CITY OF ALBUQUERQUE

RE: **Homewood Suites - 5400 San Antonio Dr. NE**
Grading and Drainage Plan
Engineer's Stamp Date 12/26/2017
Hydrology File: E18D050

DRAINAGE AND TRANSPORTATION INFORMATION SHEET (REV 10/2015)

The following is written in response to your comments (dated 11/27/17) on the subject project. The responses are in the same order as your comments.

TITLE	HOMEWOOD SUITES STORM DRAIN	
SHEET NUMBER	1

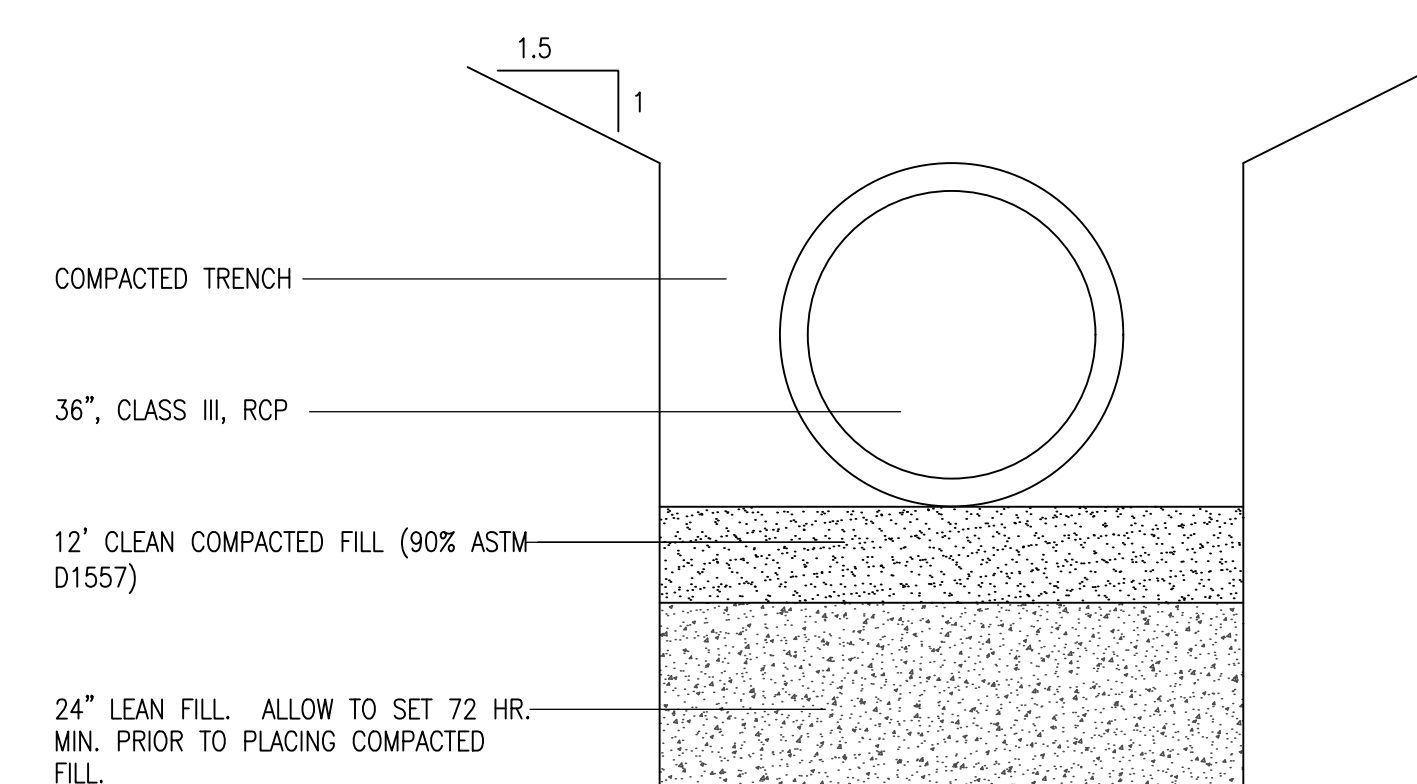
10. Profiles of the public pipes should show Q and V.
11. Add a signature block for the Landfill Gas engineer working for Homestead Suites to "Certify that this G&D Plan is in conformance with the Landfill Mitigation Plan" and provide copies of the plan and permits to hydrology prior to hydrology approval of the G&D Plan. Excerpts of the plan should be included in the DRC plans for "Information Only" prior to DRC approval.

2. The storm drain is analyzed as a series of connected culverts with the tailwater equal to the downstream headwater requirement less the drop across the manhole. This method will provide conservative values for HGL elevations and what I believe is actually happening in a storm drain as it goes through a manhole if the flow depth is more than half the pipe diameter.

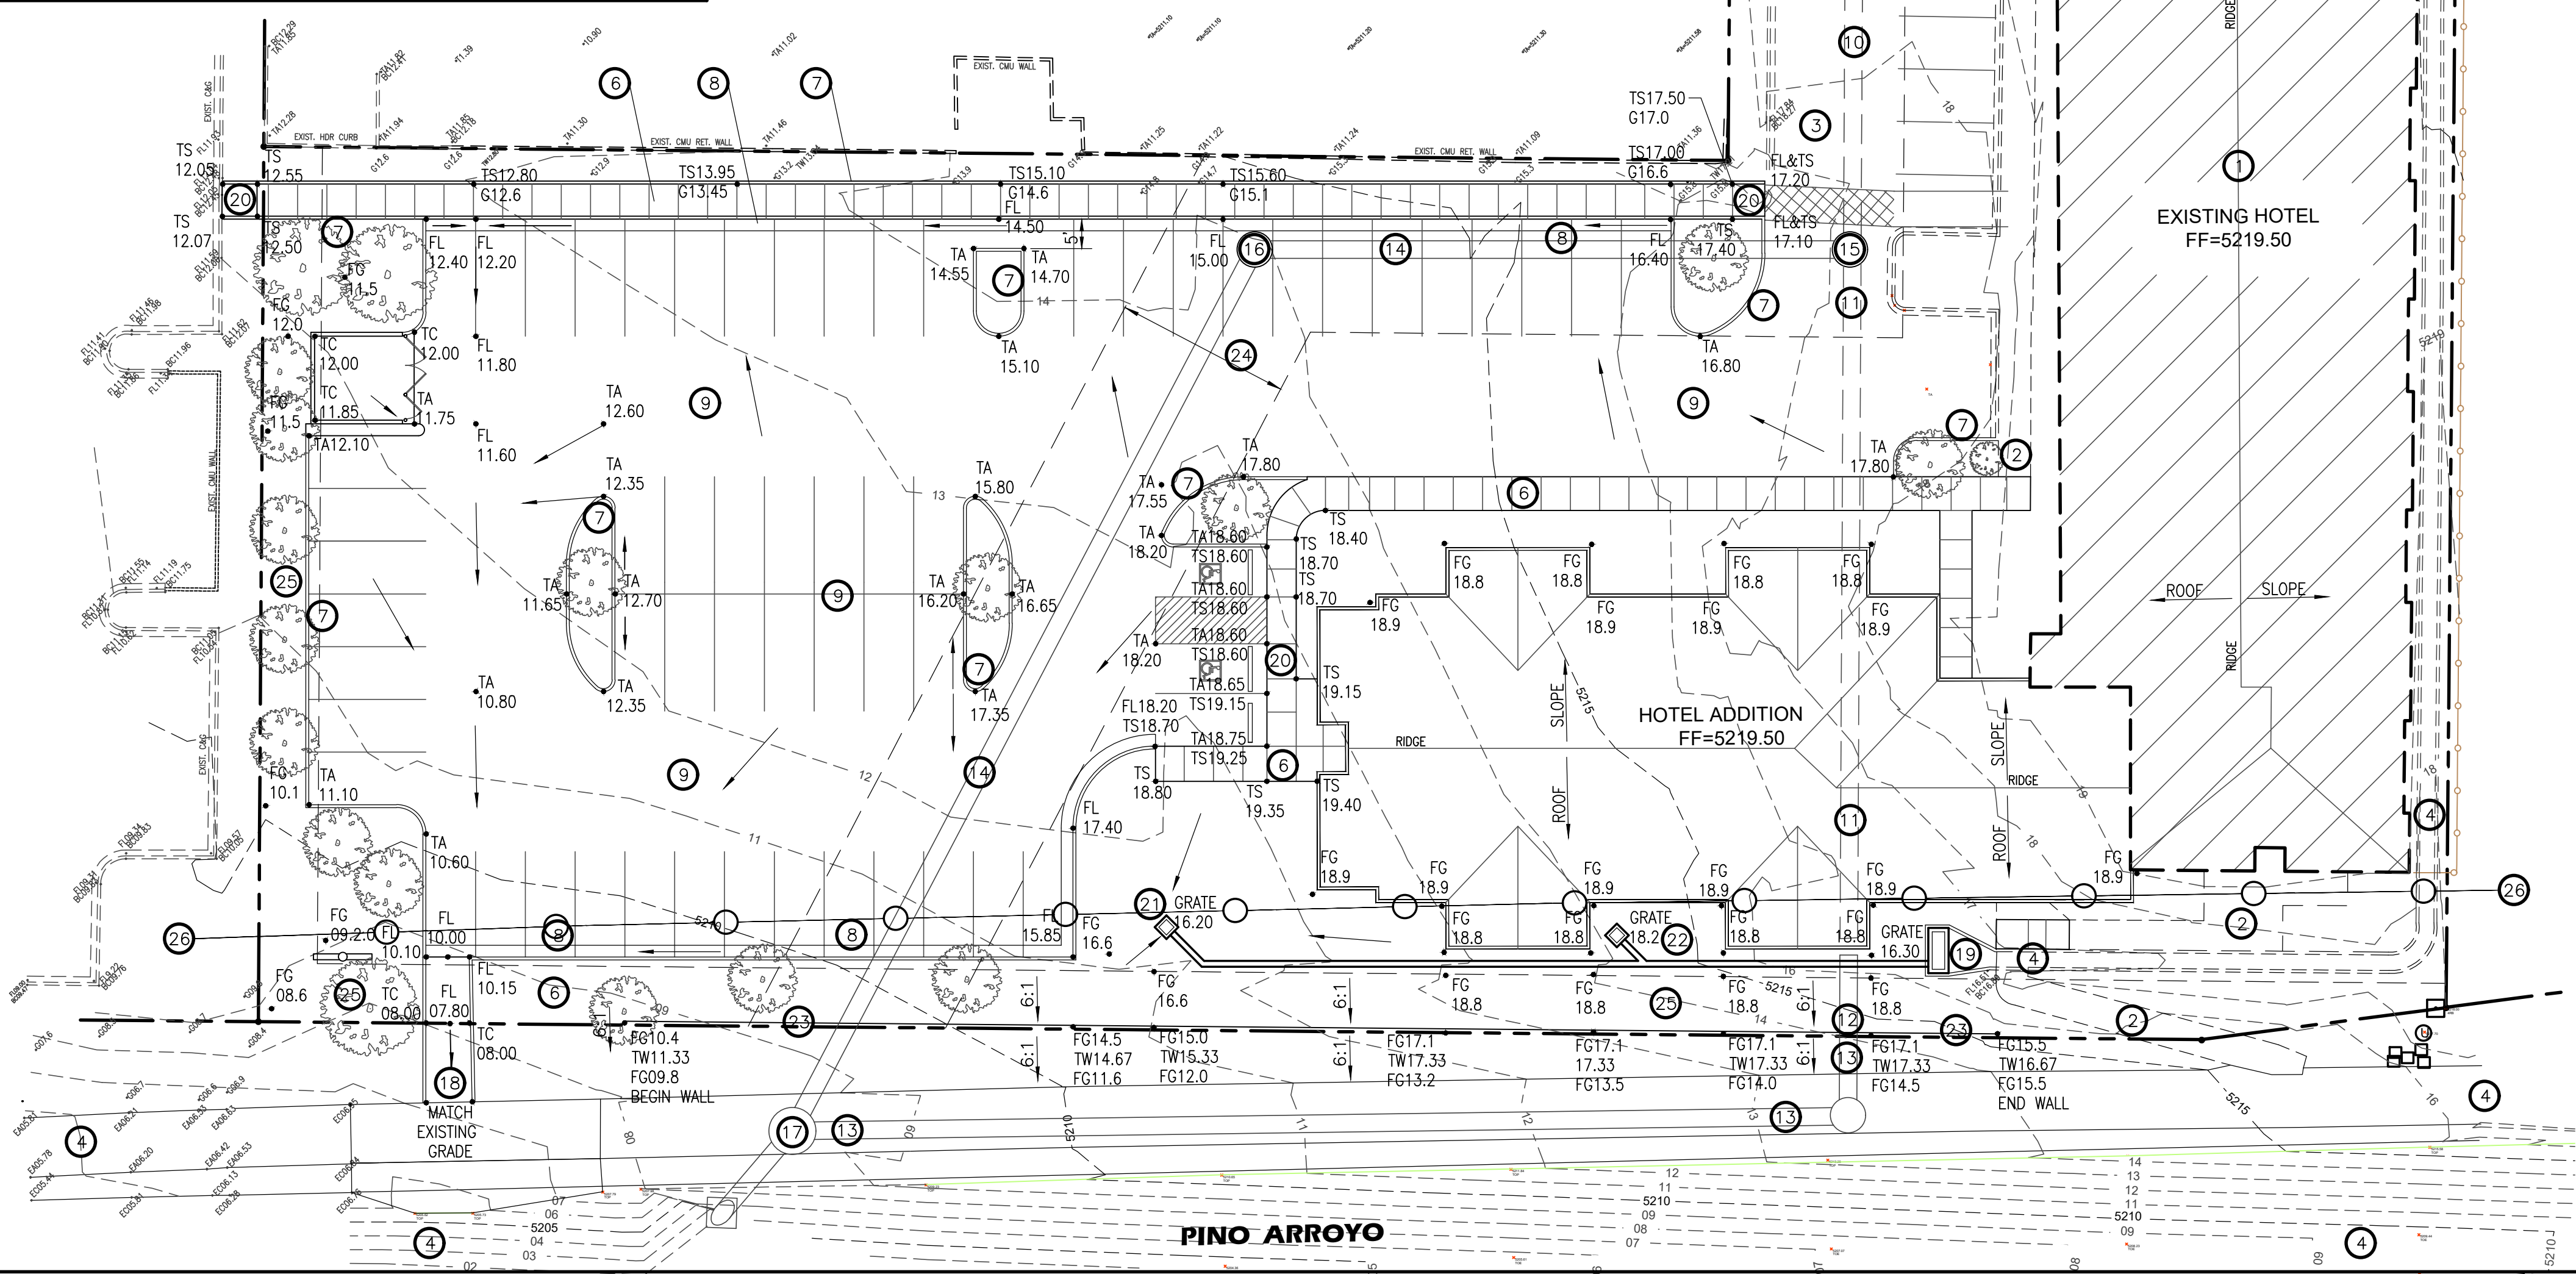
3. A temporary bridge across the San Antonio Arroyo is to be added to the DRC work order plan set that will include removal and replacement of a portion of the adjacent bike trail. The trail removal and replacement should be shown on the G&D Plan

5. Written approval from Parks Department will be required for the trail closure prior to DRC approval.
6. The existing Public Storm Drain thru this site must remain functional at all times. Notes are to be added to the G&D Plan and the DRC P&P stating that temporary diversion ditches will be constructed and maintained when the storm drain is not in service.

12. Keynote # 4 should say private instead of public, unless you can provide records showing that the channel east of the building is public, and Keynote # 17 needs to be changed to reflect the relocated pipe.

5. The items listed are public. Keynote No. 17 has been labeled on the plan.

7. One set of notes has been deleted and Note 4 of the Grading Notes has been changed.
8. A bold note has been added to the plan regarding site construction items that are to be built per City Work Order and items that are to be governed by an Agreement and Covenant document.
